SUBJECT: FORWARDS "PRESERVICE INSP PROGRAM PLAN, VOLS 1 & 2."

Subject: WPPSS NUCLEAR PROJECT NO. 2
PRESERVICE INSPECTION PROGRAM PLAN

**PRESERVICE INSPECTION
PROGRAM PLAN**

TFH
1/29/81

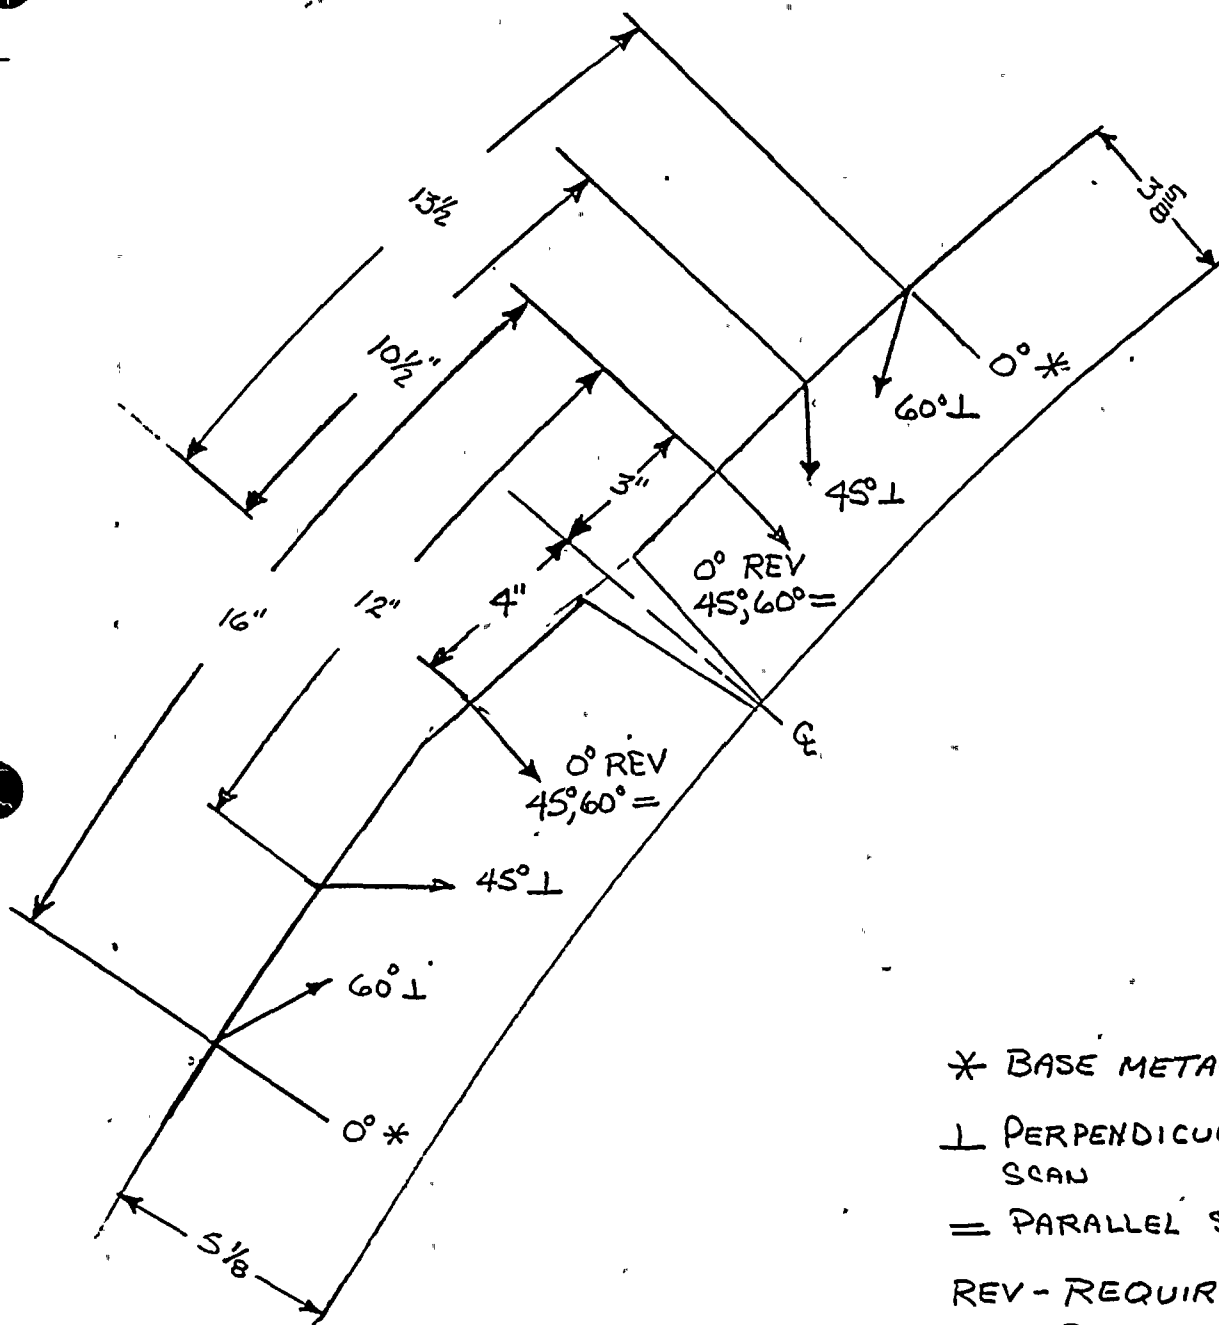
Add Figures 20A, 20B, 20C, 20D AND 20E^{20F} to procedures.
 these figures top and bottom head show weld coverage and should have
 been included in Rev 1.
